SUBJECT: Forwards response to NRC RAI to support technical review of
 util 920225 proposed license amends re OL expiration date.

Re: Turkey Point Units 3 and 4
Docket Nos. 50-250 and 50-251
Request for Additional Information (RAI) -
Proposed License Amendments
Operating License Expiration Date

RESPONSE TO NRC QUESTIONS

PROPOSED LICENSE AMENDMENTS:
OPERATING LICENSE EXPIRATION DATE

GENERAL ARRANGEMENT
INTAKE STRUCTURE
(PLAN VIEW @ EL 16'-0")

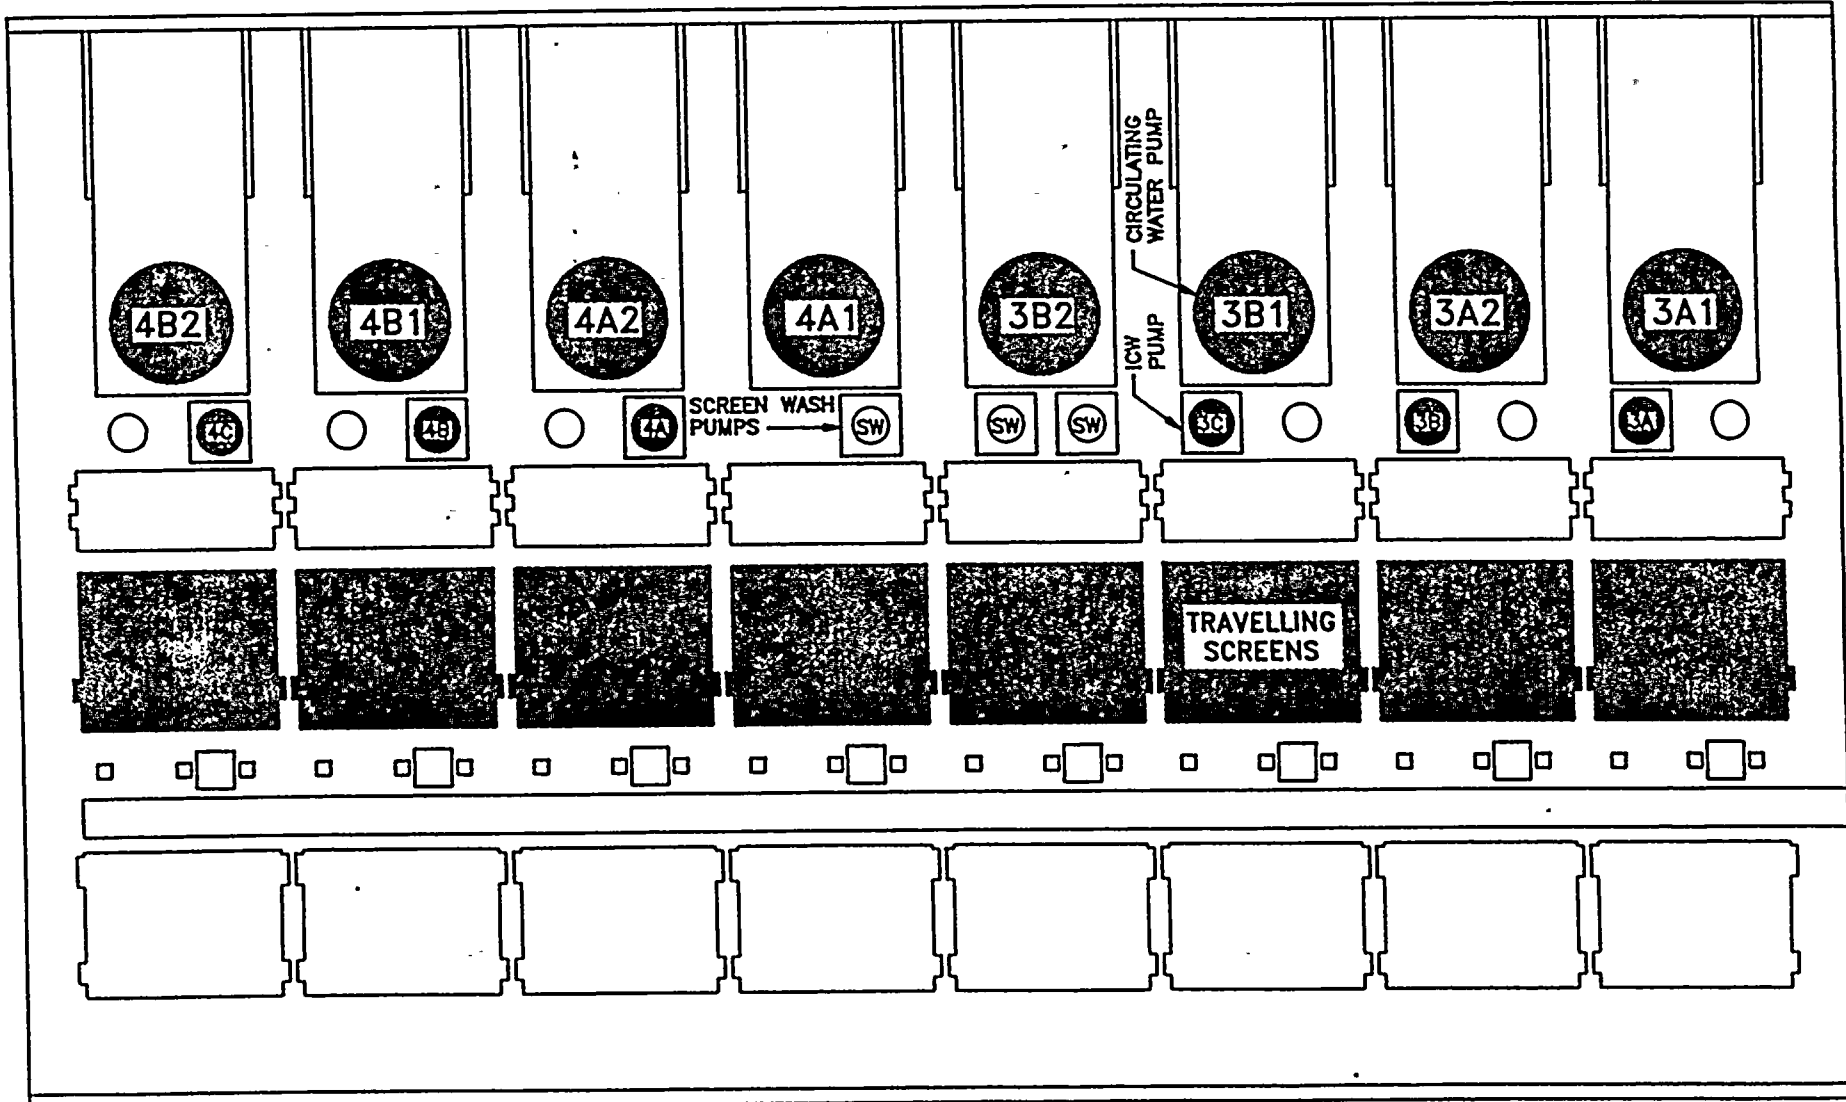
For the duration of the proposed license term, confirm the intake structure's functional capability to support the cooling water pumps and to deliver adequate cooling water to safe shutdown equipment during and following a postulated seismic event (refer to Law Engineering Testing Company on corrosion evaluation of Turkey Point intake structure dated December 4, 1986).

The main structural components of the intake structure, which are composed of reinforced concrete, are depicted in Attachment 1. They consist of the foundation, bay walls, horizontal struts including Circulating Water (CW) pump thrust beams, and deck support beams for the Intake Cooling Water (ICW) pumps, CW pumps, and travelling screen equipment.

In 1985/1986, inspections of the structure by FPL identified erosion/corrosion of the CW pump thrust beams, horizontal struts at the 1'-9" elevation, and the deck support beams for the ICW pumps. The most significant degradation was present on the CW pump thrust beams. Due to the degree of damage, the beams were replaced. Repairs were also made to the strut beams at elevation 1' - 9" and to the ICW pump support beams. These members reside in the wet/dry zone which is heavily oxygenated, are exposed directly to intake canal water which has a high chloride ion concentration, and have 3 inches of concrete cover over the reinforcement (as required by the American Concrete Institute (ACI) code of record at the time of construction). Other

elements of the structure, including the bay walls, which have 6 inches of cover, and the struts which are normally submerged, did not exhibit any significant degradation.
